# Town of Hilton Head Island Regular Design Review Board Meeting

Tuesday, June 24, 2014

## AGENDA

S1 Elevation

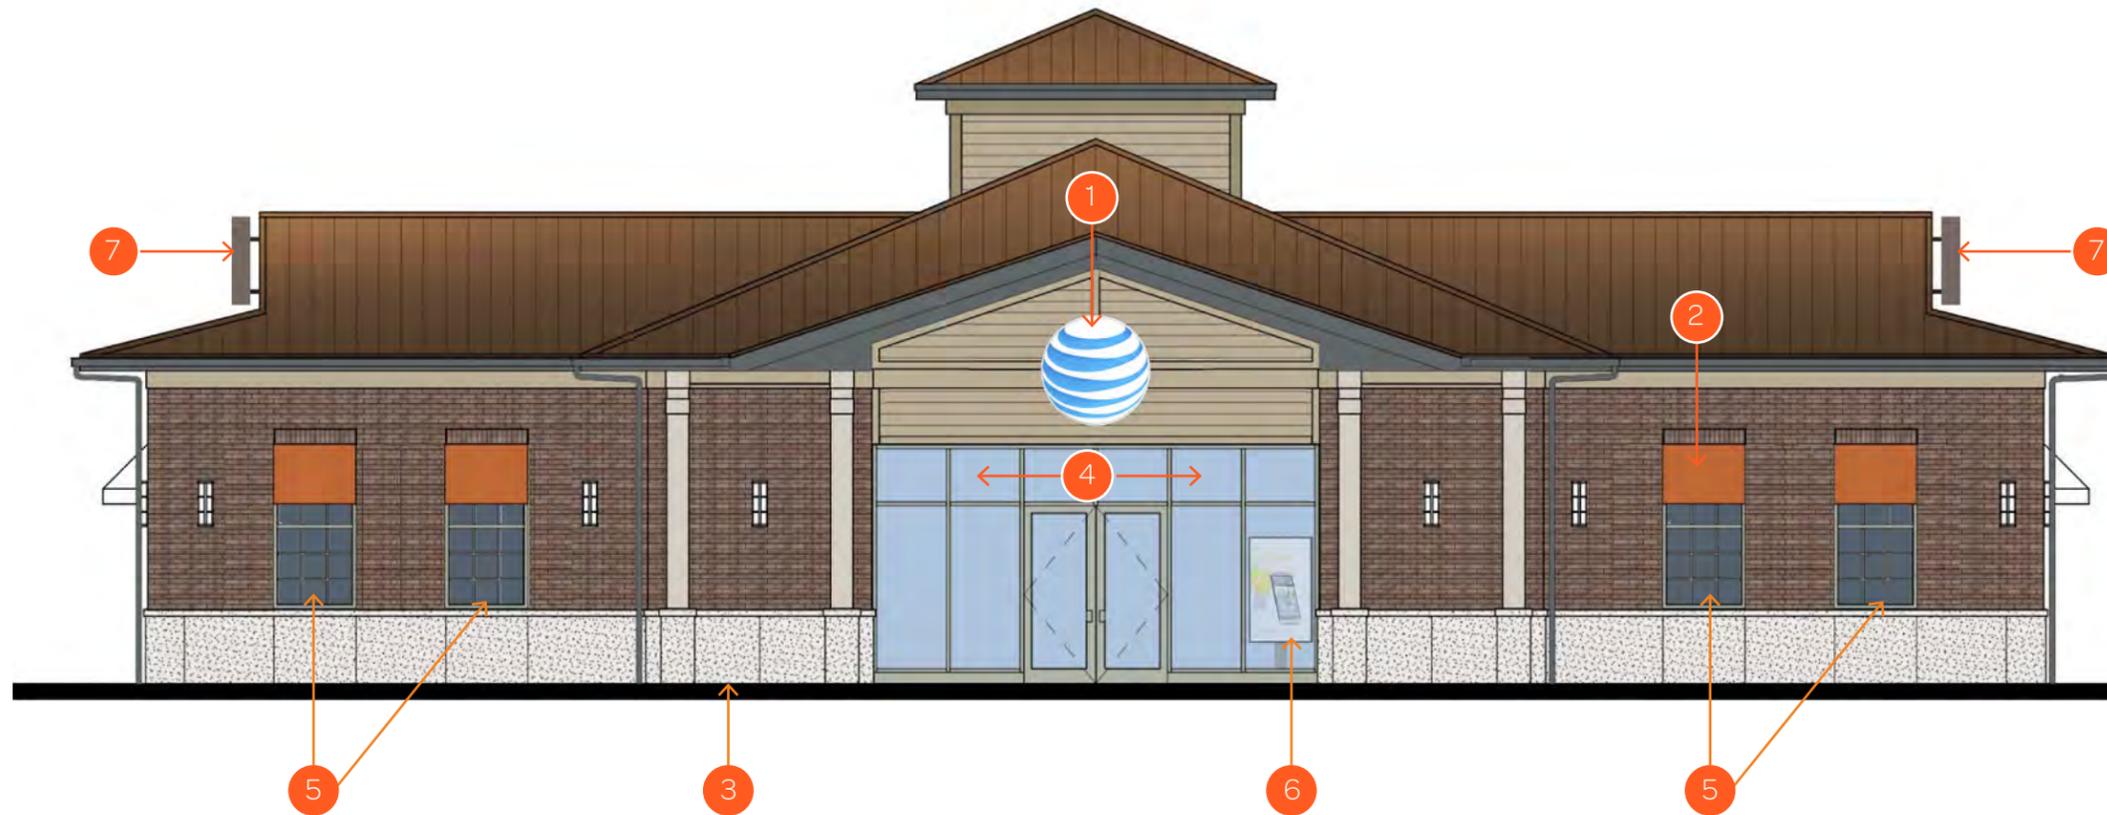
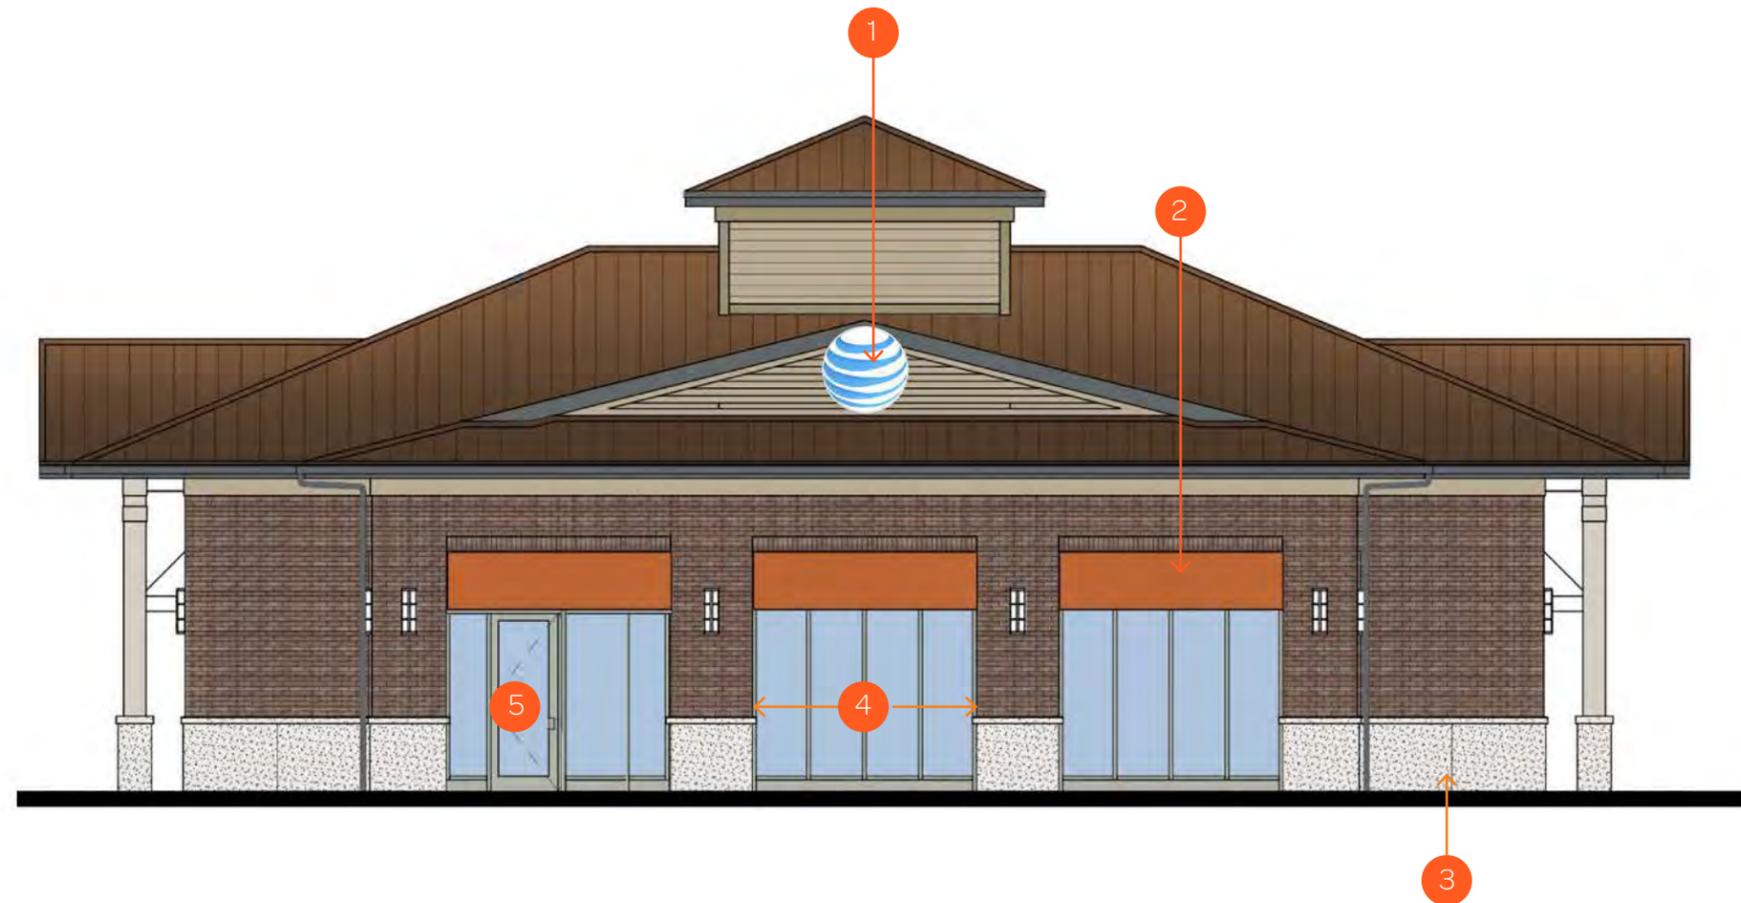
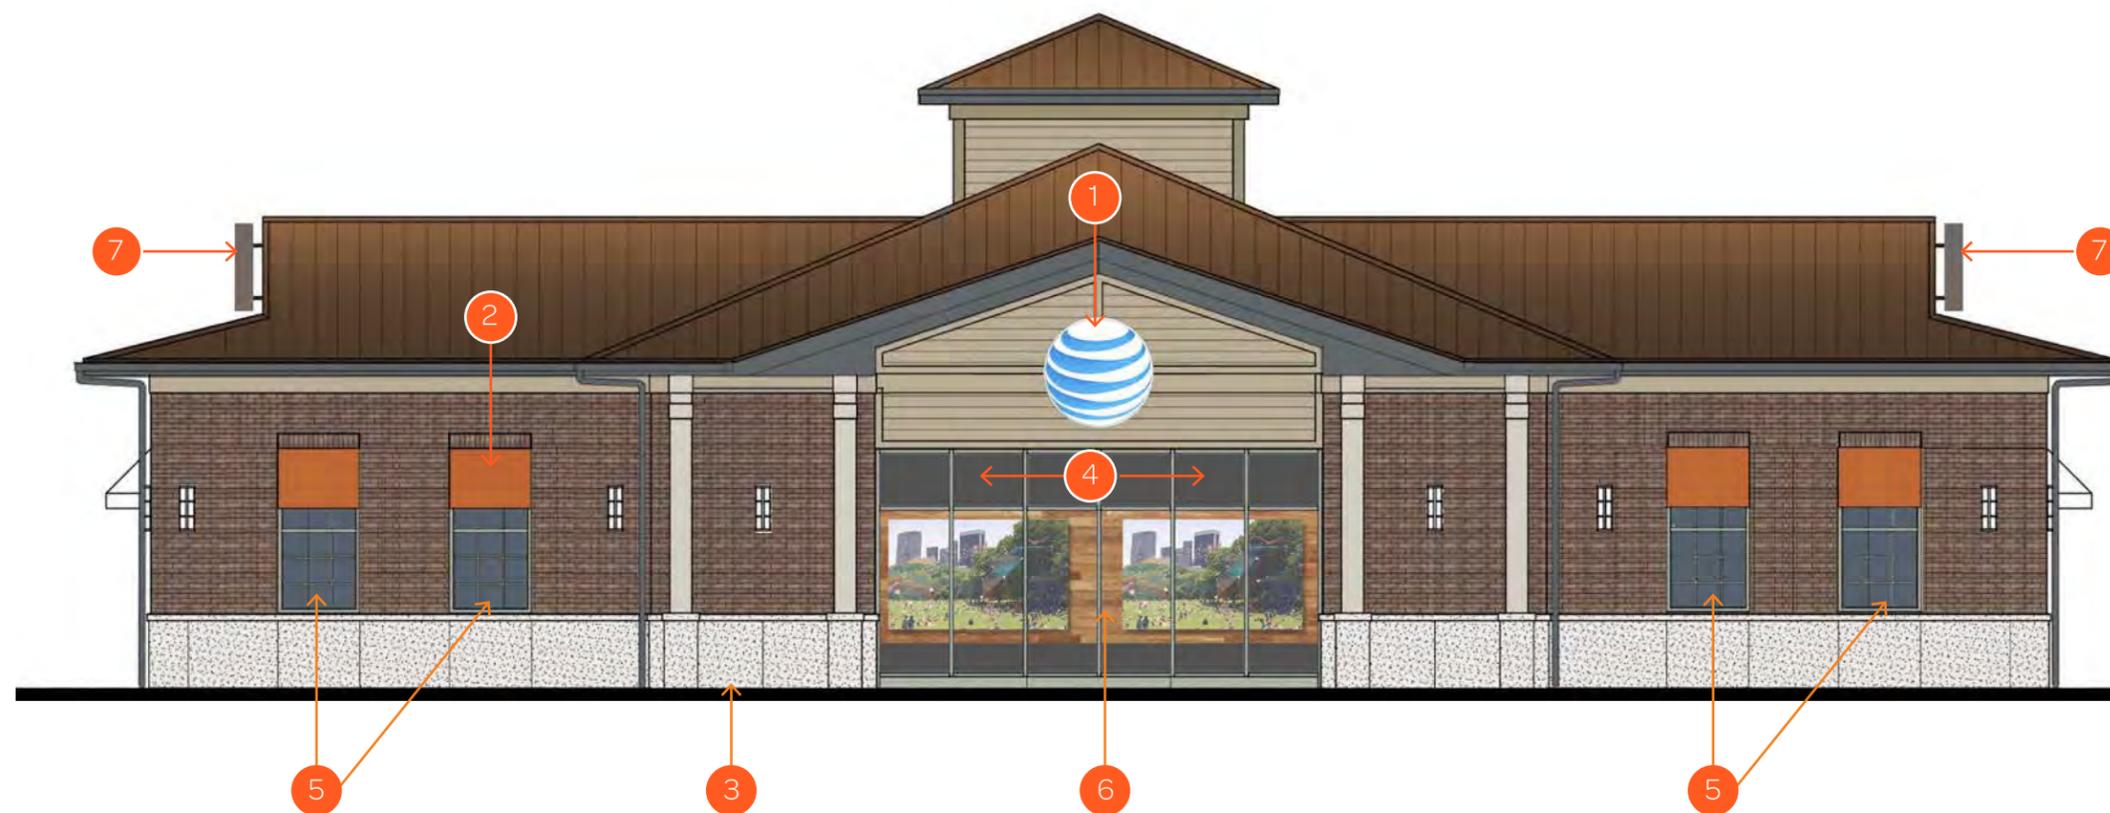
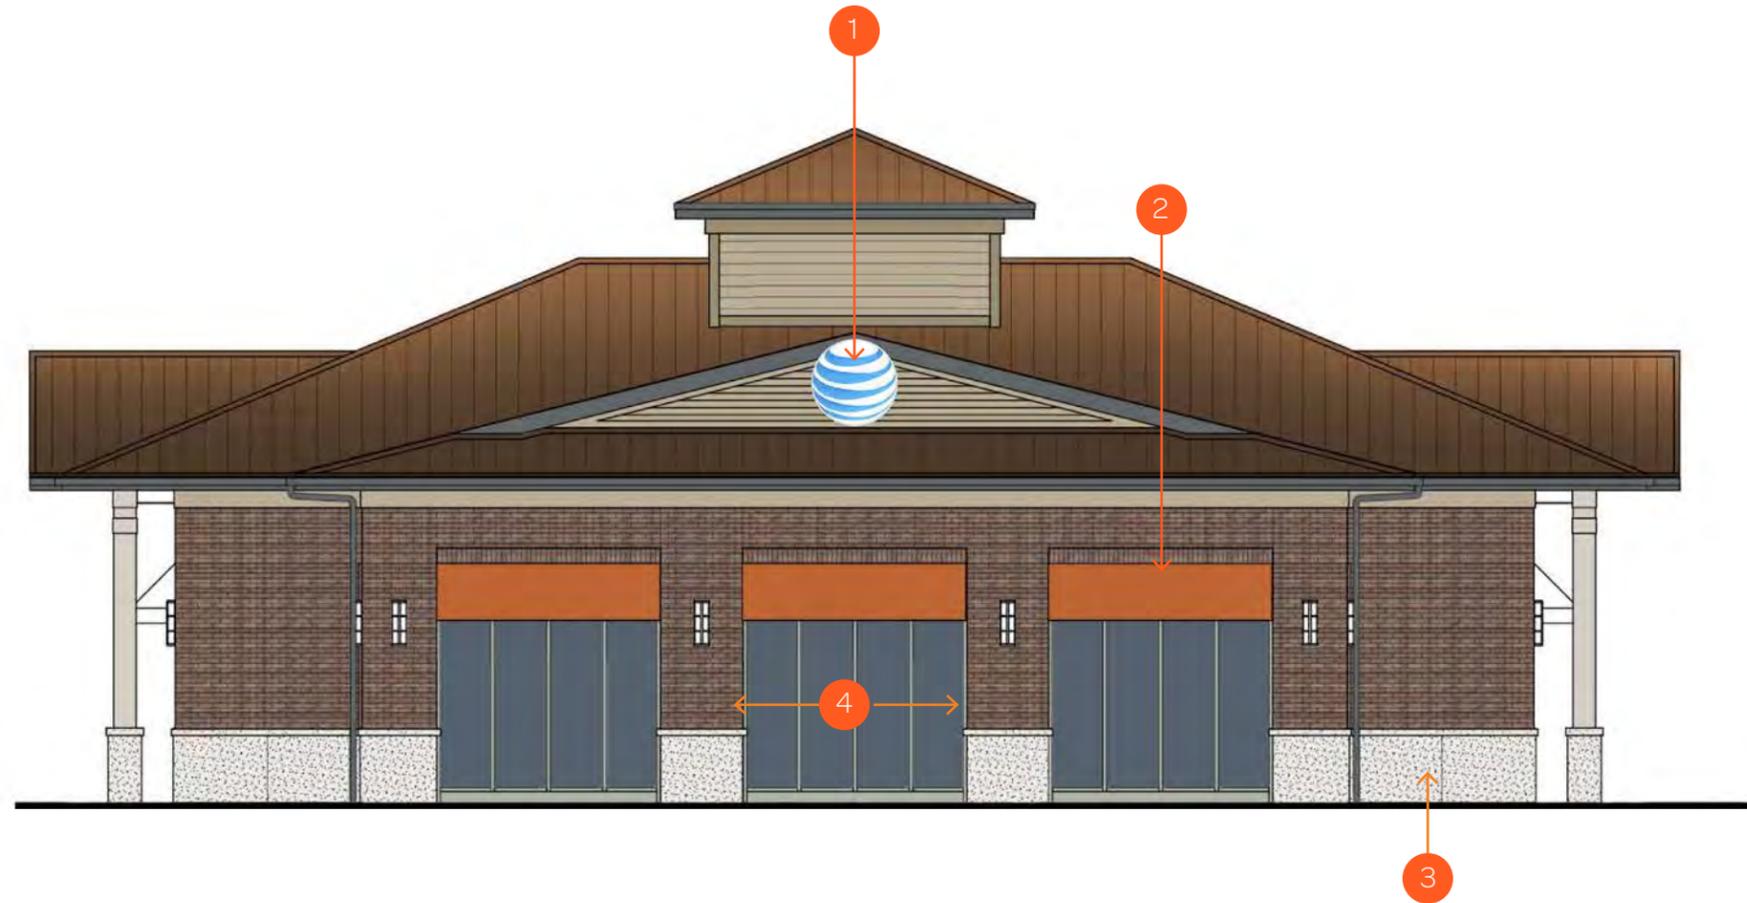
South Elevation: The double entry doors with sidelites and roll-up garage doors on either side have been redesigned as 4 panels of storefront in each wall section with awning over each opening. The AT&T logo "globe" is mounted beyond the roof overhang at the roof gable vent.

Applicant proposes alterations to the partially completed building 101 (across from the Jo A Bank/GNC Building) based on a specific tenant that was unknown at the time of original approval. Paned windows with shutters have been changed to paned, spandrel, windows with awnings. Double entrance doors and roll-up garage doors on ends have been changed to panels of storefront with awnings. Proposed awning color was previously discussed by DRB and applicant but not specific to a building. Signage will require separate sign permit application/review. Site plan and landscape plan should be updated to direct pedestrians away from east side of building and to entrances on west and north sides of building.
